ADDENDUM No. 2
December 10, 2025

CALAVERAS COUNTY WATER DISTRICT
ARNOLD WWTP IMPROVEMENTS PROJECT

This Addendum No. 2 ("Addendum") as dated above modifies certain Bidding Documents issued by the Calaveras County Water District in connection with the District's Arnold WWTP Improvements Project. There are no other amendments to the Bidding Documents other than expressly contained in this and any other Addenda issued by the District.

M600
DRAWING NUMBER

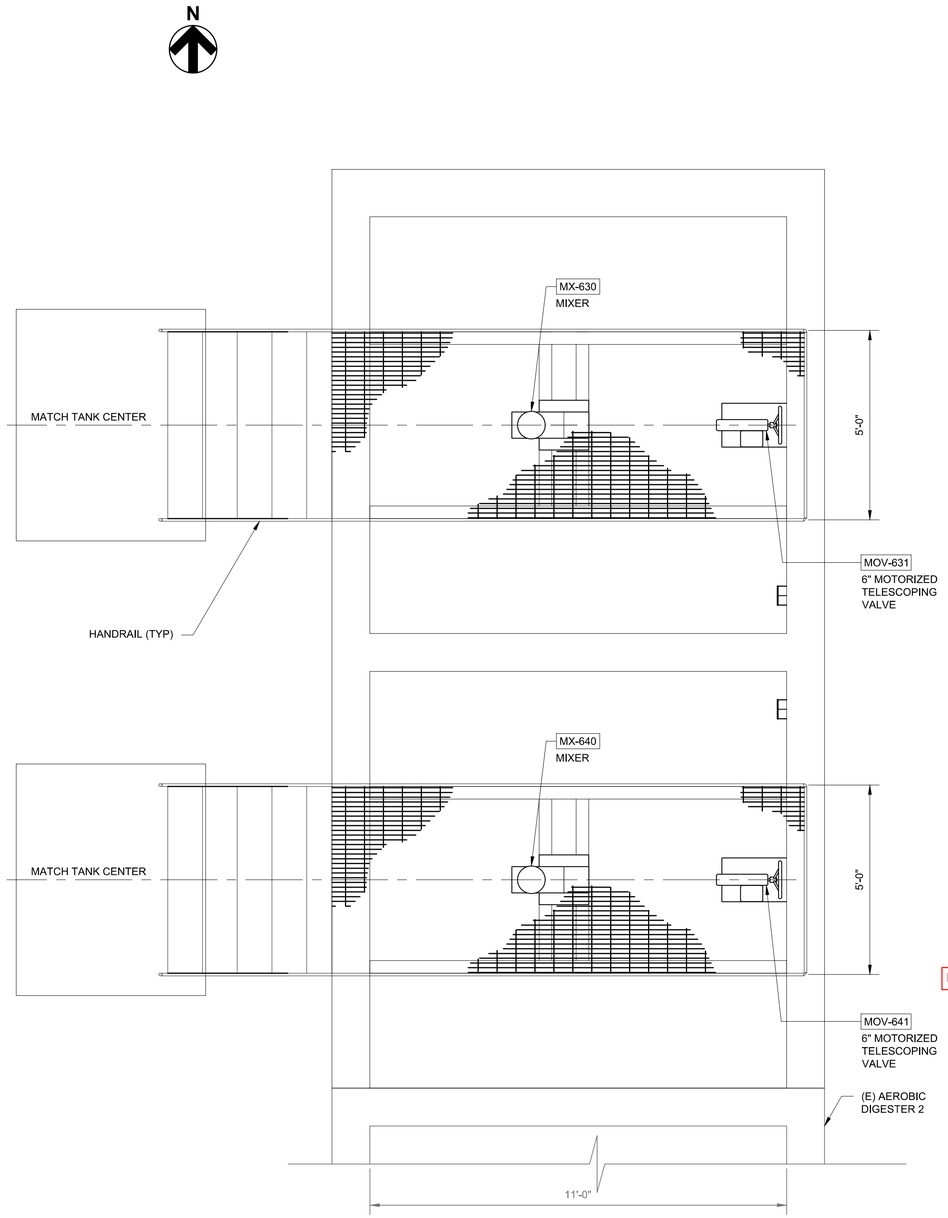
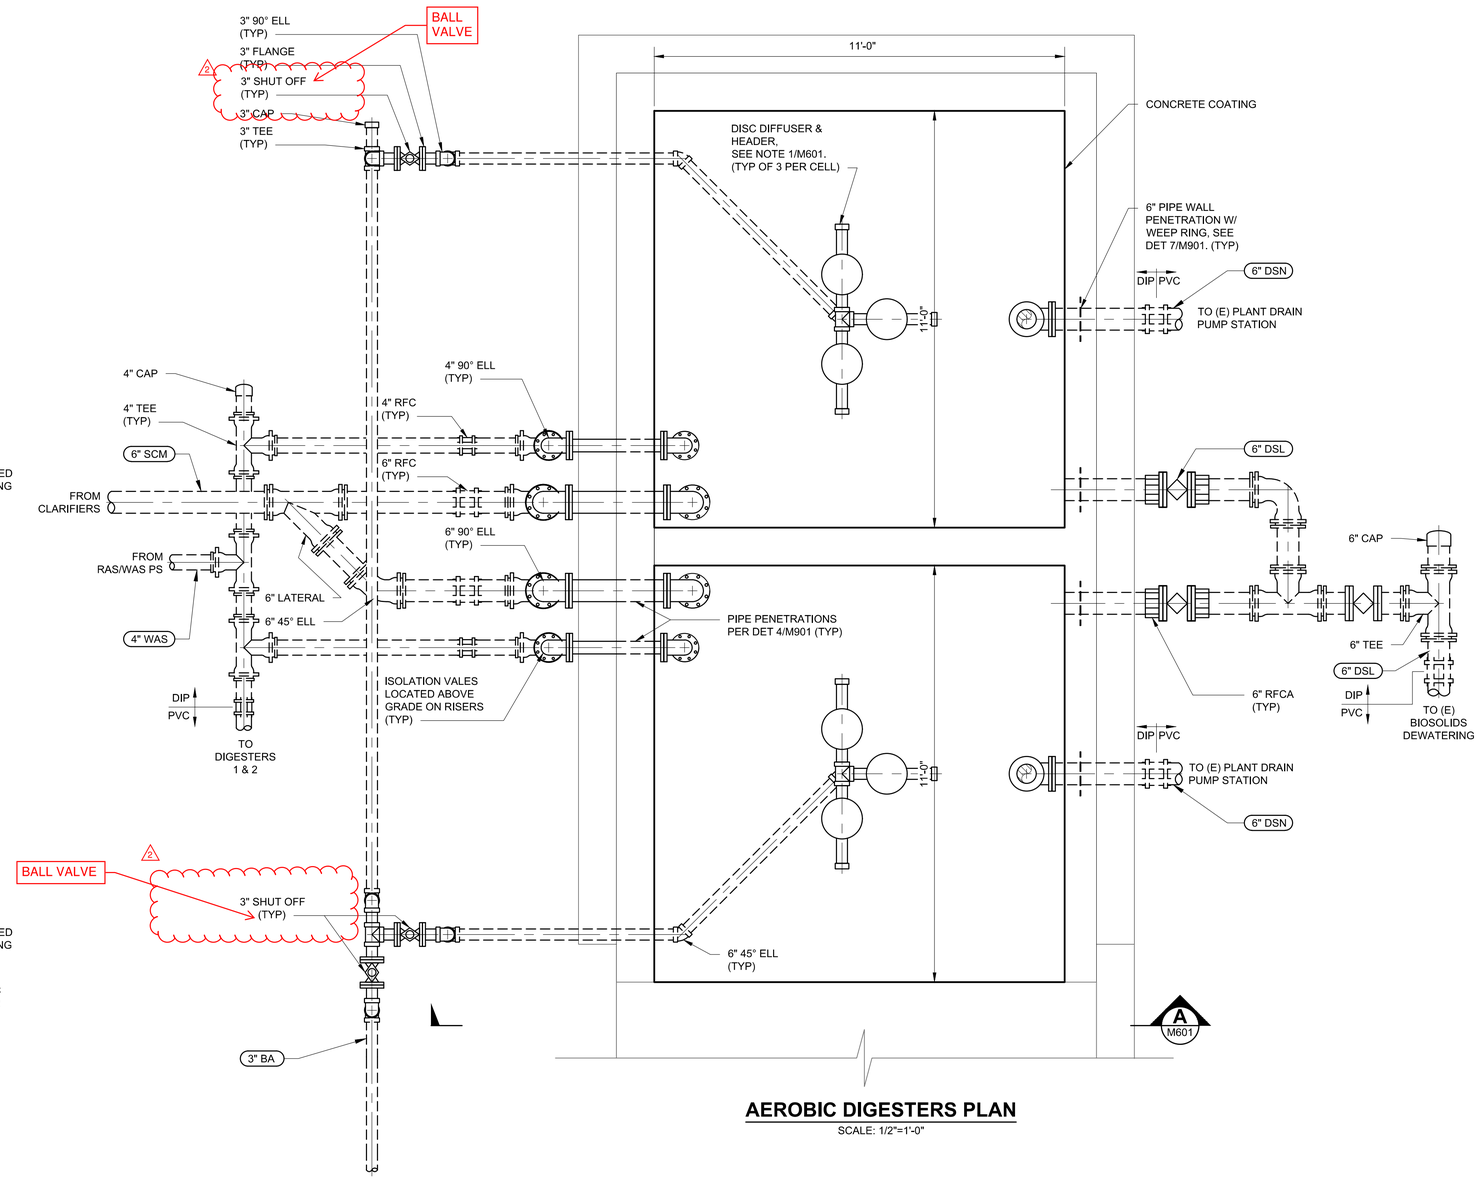
17. **Question:** Sheets M600 and M601 show 3" SHUT OFF GVs on the BA lines. The use of gate valves is unusual on an BA lines. Should these actually be BFVs per spec section 15100, 2.03 or should these be ball valves as called for in the PIPING SYSTEM SPECIFICATION SCHEDULE – SYSTEM 14 for BLOWER AIR (BA)? If ball valves, are they per spec section 15100, 2.06?
Answer: Shut off valves for exposed air pipes shall be ball valve type per section 15060. Refer to 15100-2.06 for ball valves specification. See Addendum #2 revisions to Sheets M600 and M601.

21. **Question:** There is no specification document for the Gate Valve for the Blower Airline application (Drawing document M-600).
    Answer: Shut off valves for exposed air pipes shall be ball valve type per section 15060. Refer to 15100 for ball valves specification.

M601
DRAWING NUMBER
SHEET 26 OF 76

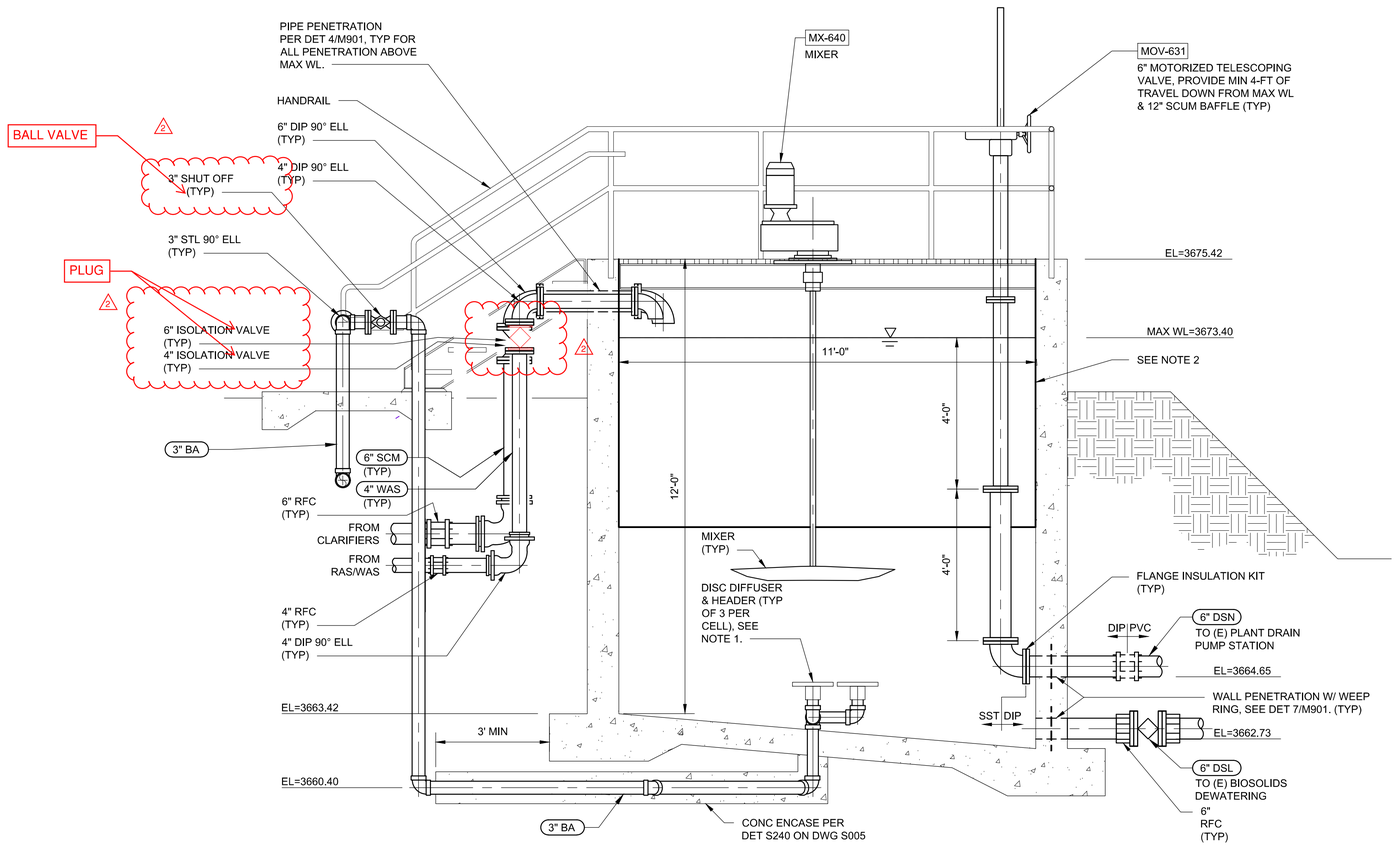
19. **Question:** Drawing sheet M-601 does not include a specification sheet or a list of manufacturers for the 4" and 6" isolation valves. (Drawing Sheet M-601).
Answer: See Addendum #2 changes to Sheet M601.

E010
DRAWING NUMBER

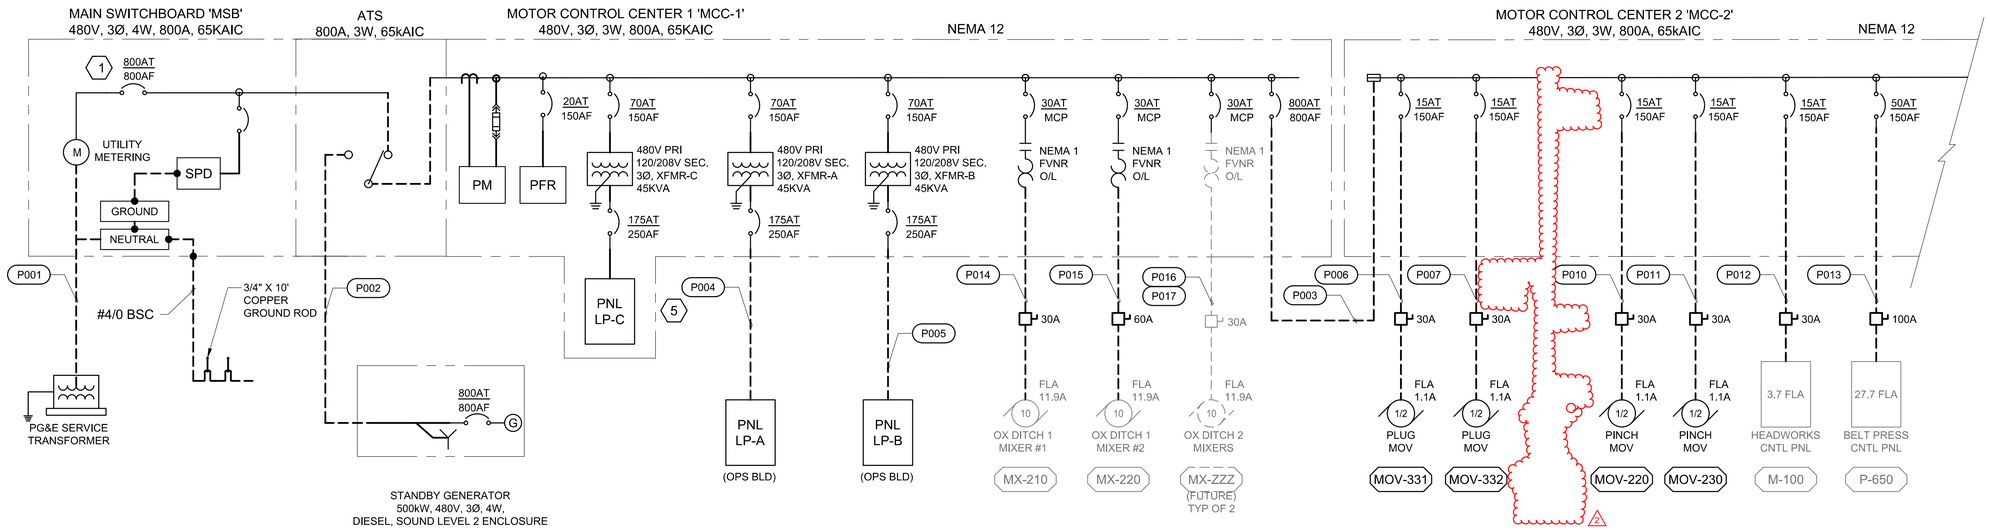
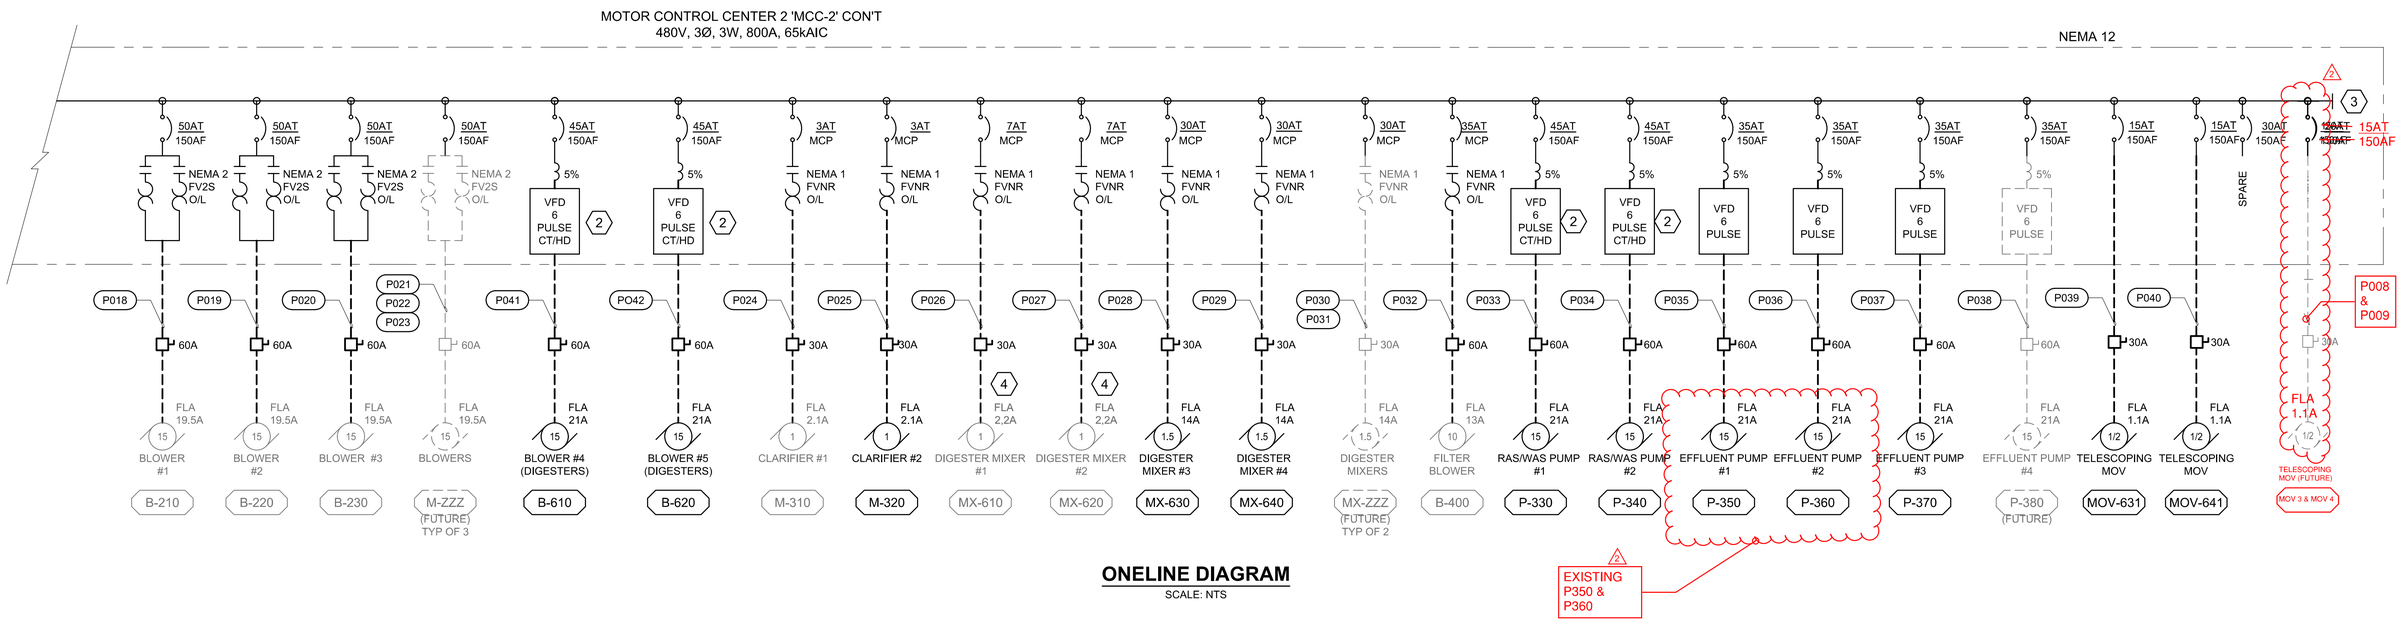
25. **Question:** Spec section 16208, 2.05 Load Bank calls for the supply and installation of a load bank adjacent to the generator as shown on the contract documents. The electrical one line and site plans do not show a load bank. Please clarify if a load bank is required.
    Answer: No Load Bank per drawing E010.

E100
DRAWING NUMBER

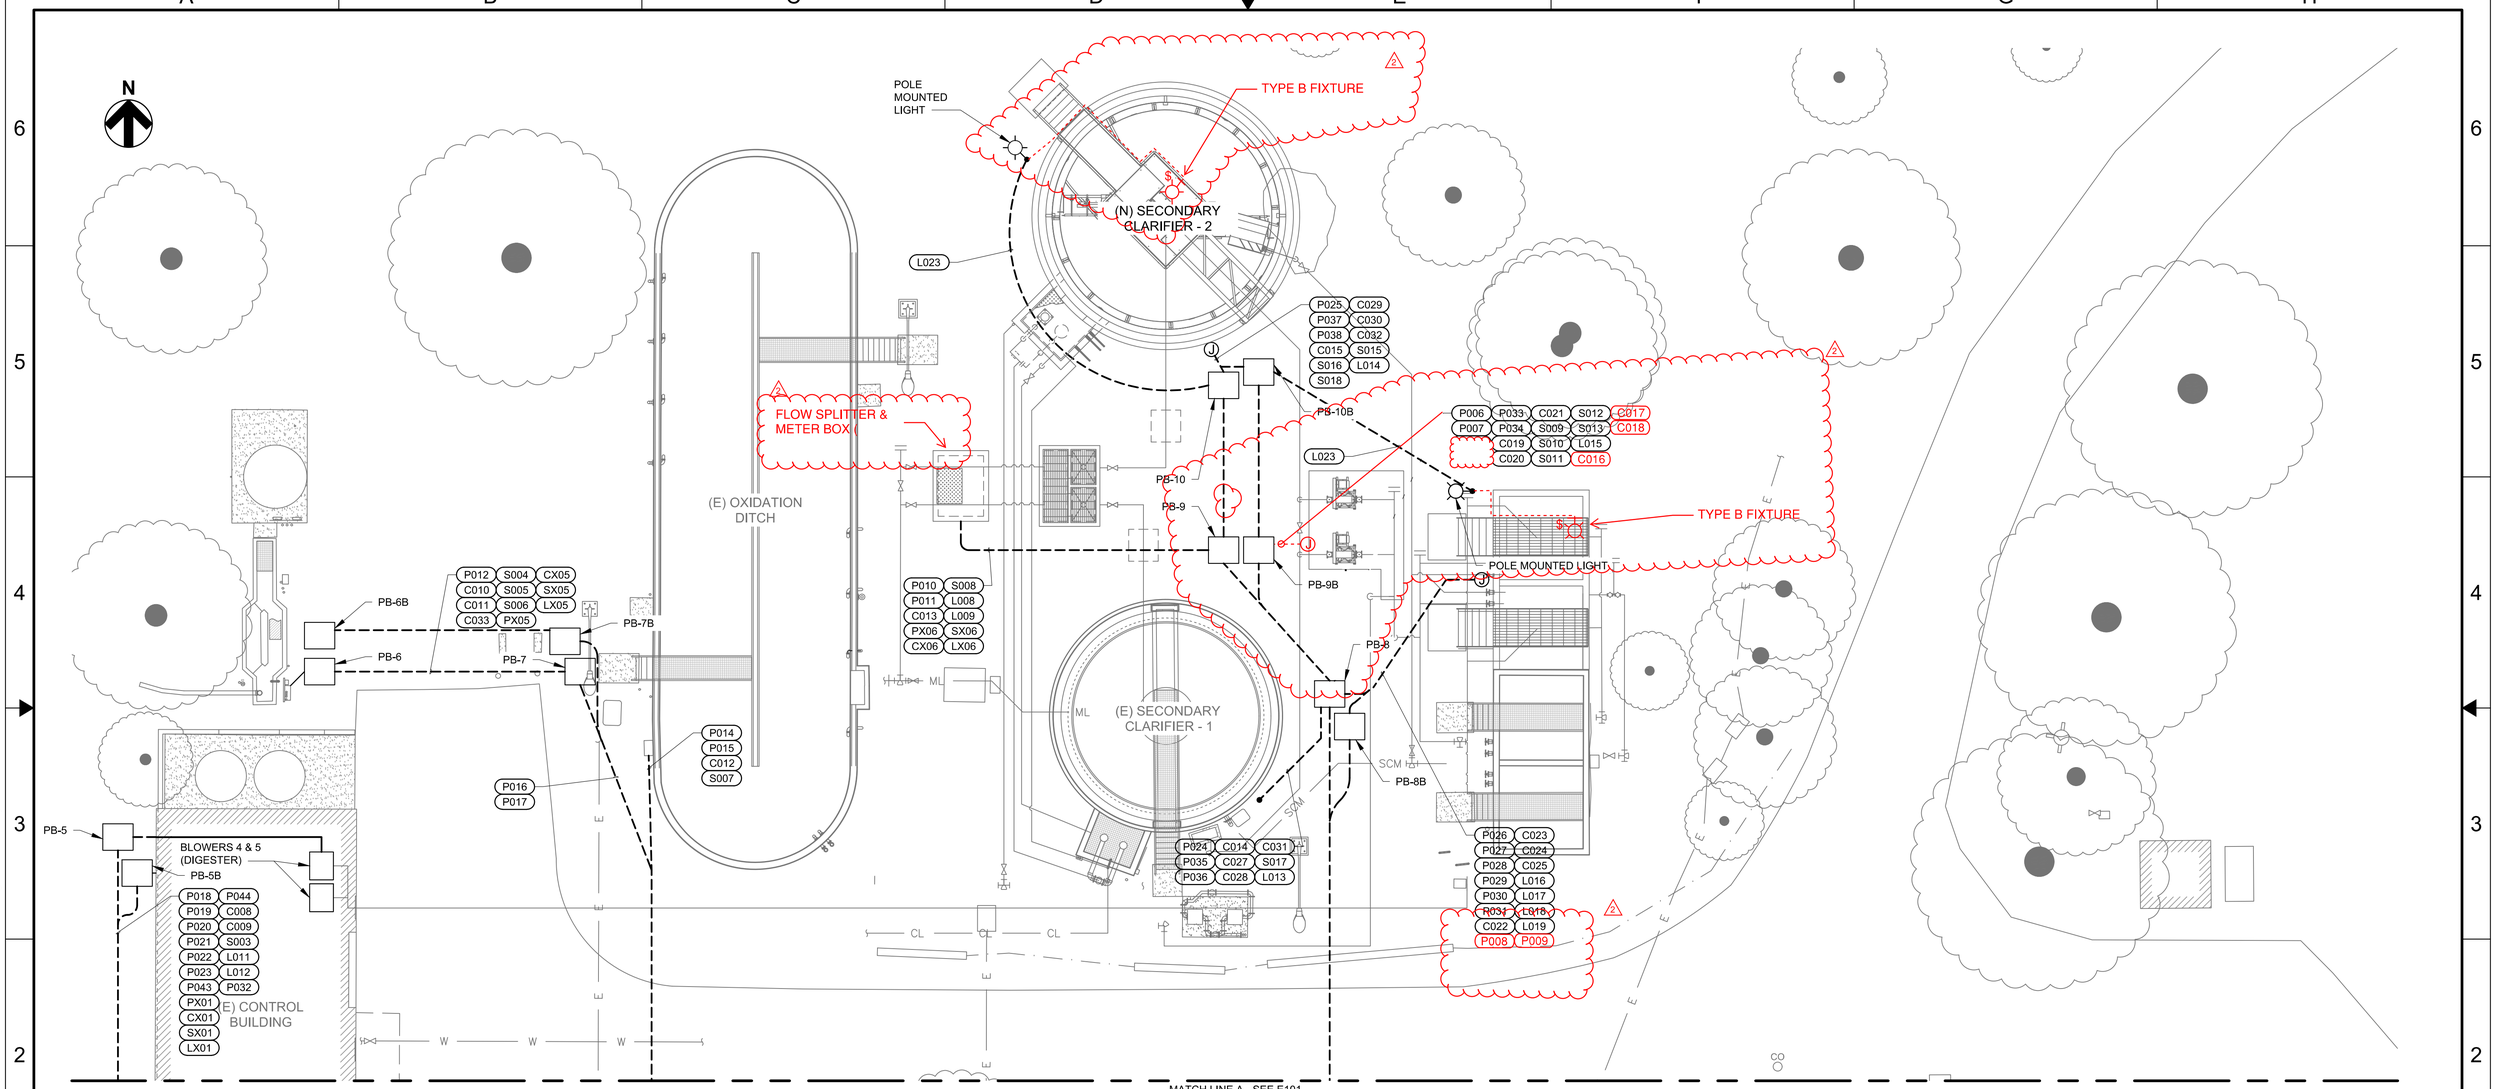
3. **Question:** Is lighting fixture Type B used on this project? There doesn't appear to be a symbol for the "Stanchion" mounted fixtures on Drawing E001, and the fixture types from the light fixture schedule are not shown on the plan sheets for verification.
   Answer: No See Addendum #2 changes to Sheet E100.

7. **Question:** Requests for clarification made relating to conduit identifiers the RAS/WAS pump station on E500.
   Answer: See Addendum #2 changes to Sheets E100 and E500.

8. **Question:** Drawing E100 shows conduits L018 & L019 routed to the Aerobic Digester Expansion area. The conduit and conductor schedule calls for these conduits to be circuits for the generator. Please clarify if all the required conduits are shown to the Aerobic Digester area on Drawing E100 and confirm the routing and final location of L018 & L019.
   Answer: Correct, these conduits should be routed to the Standby Generator

24. **Question:** Conduits P008 and P009 are referenced on drawing E100 as routed to the RAS/WAS area. The conduit and conductor schedule calls for these conduits to be routed to Plug MOV 3 & 4 (Future). There is no reference of the conduits or future MOV's on drawing E500. Please provide the location of the future MOV's.
    Answer: See Addendum #2 changes to Sheets E100 and E500.
